Service Bulletin

SAFETY RECALL

2003-2004 GL1800/A Frame Weld

(This supersedes GL1800/A #18, dated February 2005)

WELDING OVERVIEW

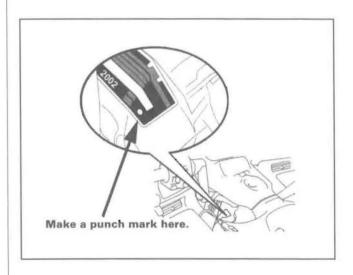
A qualified TIG welder will weld the frame following the procedures in the 2002-2003 GL1800/A Frame Weld Safety Recall Welding Manual.
